## TECHNICAL GUIDANCE NOTE

### Fire Risk Assessment of External Cladding Systems on High Rise Residential Building (Phase 3 Report)

101 - 704 Shannon Apartments

Commissioned by: A2Dominion Group

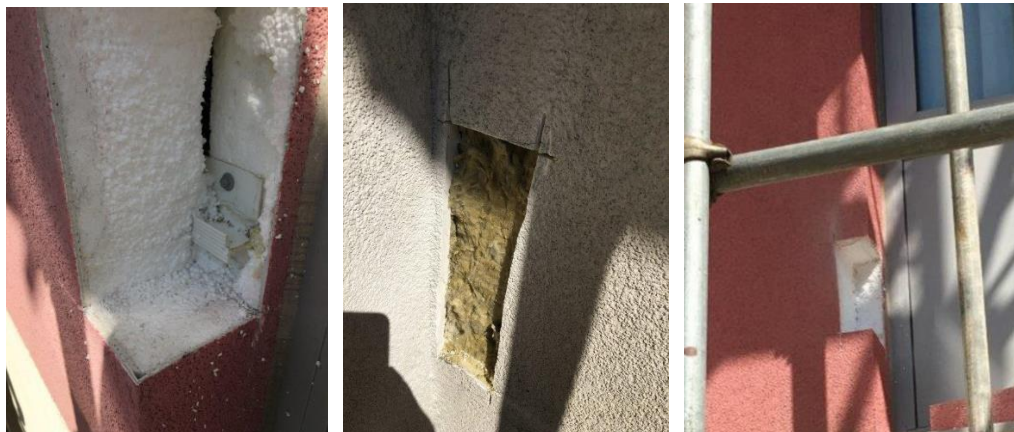
The mineral wool cavity barrier appears to be full-fill back to the cementitious board. However, it was noted that a cavity between the cementitious board and masonry, up to 18mm deep in places, has been created. There are no fire breaks in these cavities so it is assumed they are continuous from floor to roof level. A cavity barrier should be present at each compartment floor and wall level in this cavity.

No cavity closers were found during opening up around windows and were present in some locations, but not all, where compartment walls were located.

Cavity barriers are required to be provided at each floor level and compartment wall. This could be achieved by opening up the render at each floor level and inserting a full width cavity barrier before making good the render.

Cavity barriers are also required around openings in the facades such as windows and doors.
